## Application by One Earth Solar Farm Limited for One Earth Solar Farm

### The Examining Authority's written questions and requests for information (ExQ1)

Issued on 7 August 2025

Q1.0.13	The Applicant	<p><b>Works Plan</b></p>

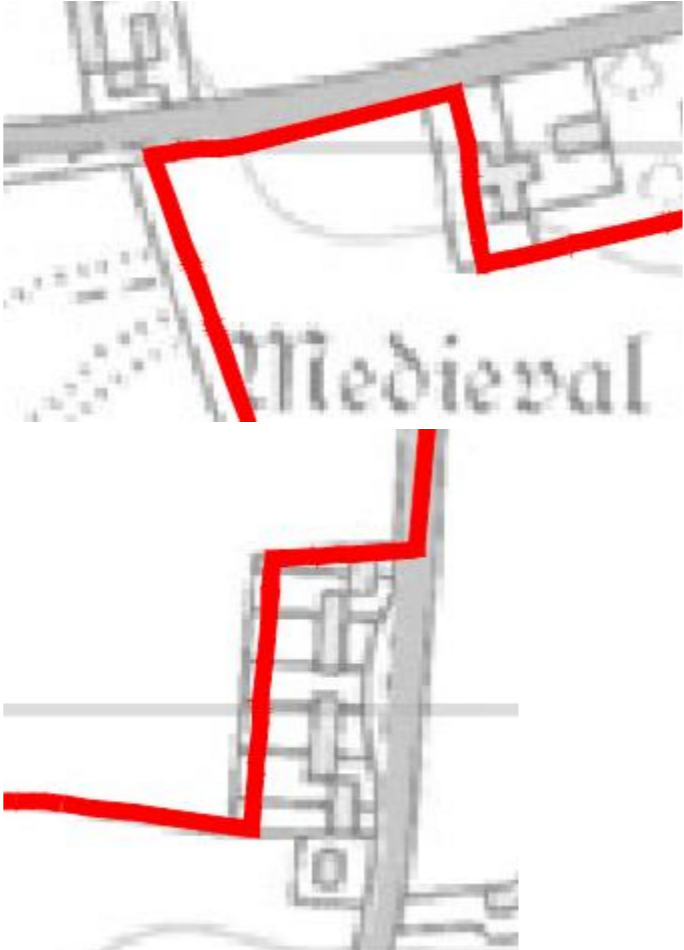
ExQ1	Question to:	Question:
		<div></div> <p>Sheet 1 appears to have an error as indicated in the snip – please clarify or correct as necessary</p>
Q1.0.14	The Applicant	<p><b>Plans</b></p> <p>The Location Plan and the Land and Works Plans do not appear to have the same boundaries. For example, at Roberts Close the location plan appears to include parts of the gardens to these properties, in addition the boundary around Whimpton Moor Medieval village does not appear to correspond, nor does the boundary to the residential property to the east of this.</p> <div></div> <p>It is important that these documents align, please prepare a location plan, that aligns with the land plans and works plans.</p>
Q1.0.15	The Applicant	<p><b>Mitigation</b></p> <p>(1) Is there a flow chart showing the interrelationship between the dDCO, the Requirements and the various outline mitigation plans? If not can one be provided</p> <p>(2) Within a number of documents (DAD, ) etc. measurements are identified to be limited by way of ‘above ground level’ (for Power Conversion Stations 6m ) how is this to be verified?</p> <p>(3) Is the topographical survey within the FRA (Appendix A1) the basis of what should be relied upon as showing the detailed baseline which should then be included in the Certified documents and specifically referenced as such?</p>
